Service Manual

AV Control Stereo Receiver

SA-EX800

Note : • This Simplified Service Manual is provided to indicate the main differences between the original model no. SA-EX900(P) and the subsequent model SA-EX800 (P).

■ Cabinet Parts Differences

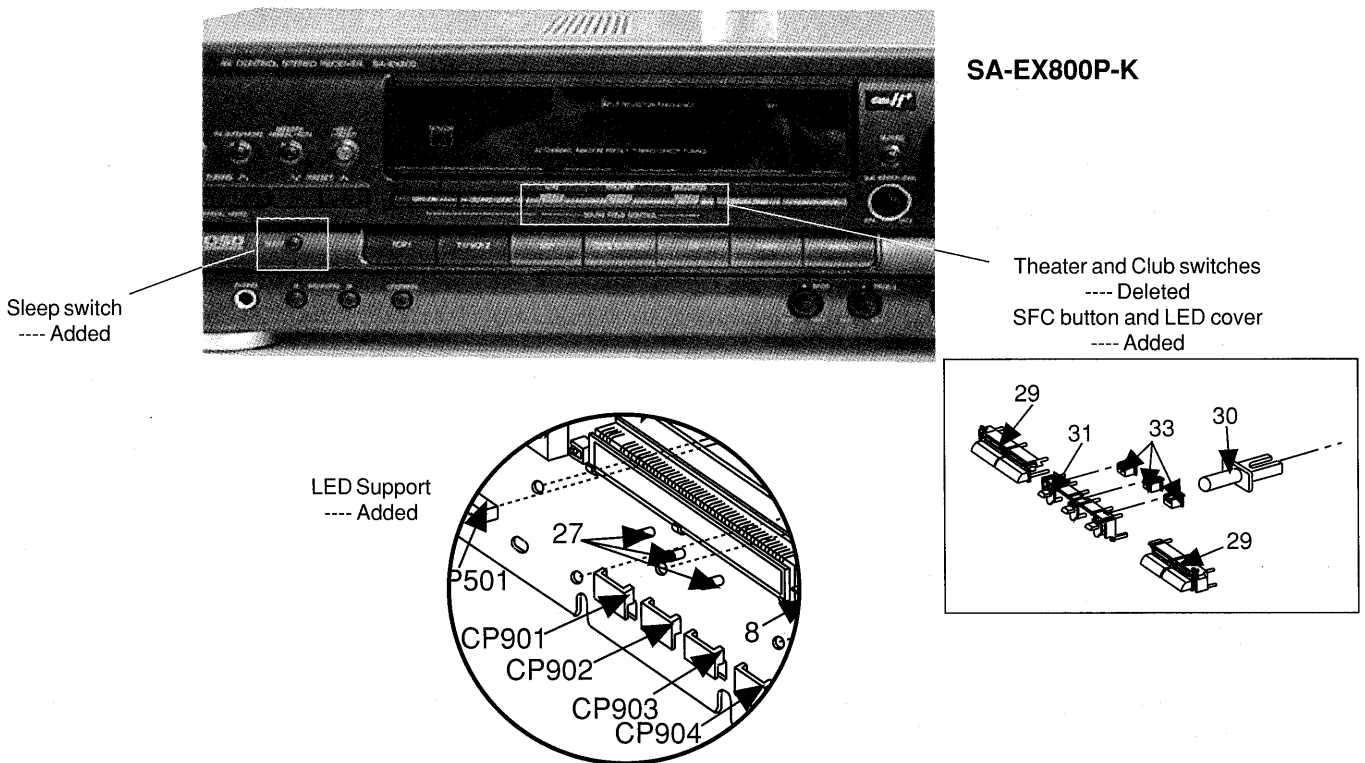
Note: These differences apply to "Operation Checks and Main Component Replacement Procedures" and "Cabinet Parts Location"

E HEADPHONE JACK P.C.B. (REP2327A-S ==> REP2329A-S)

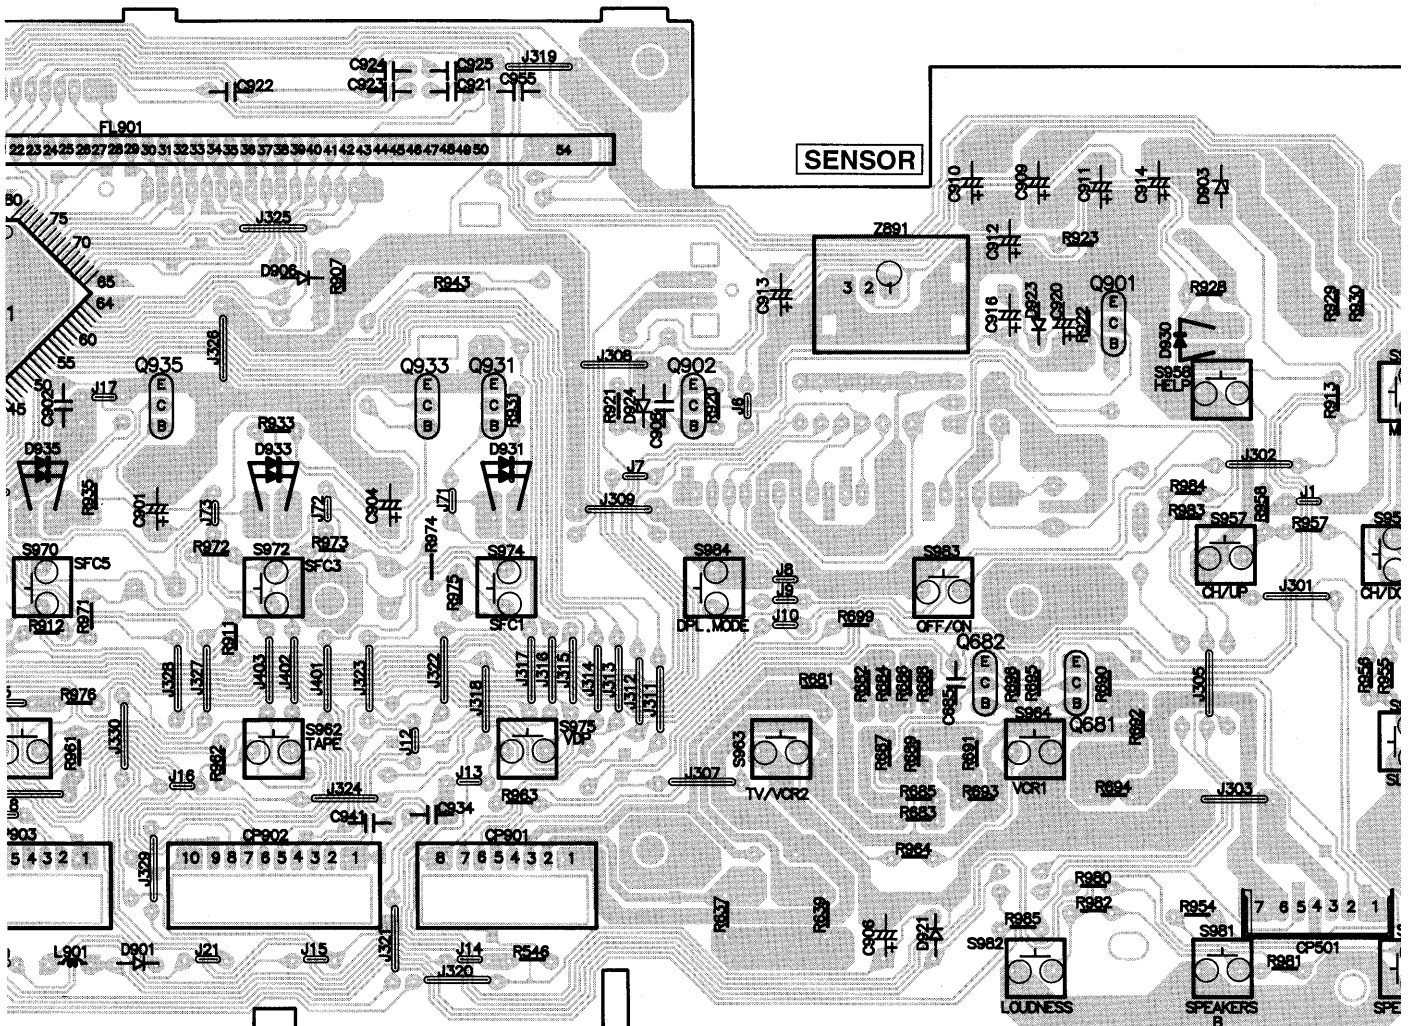
L VCR2 INPUT P.C.B. (REP2327A-S ==> REP2329A-S)
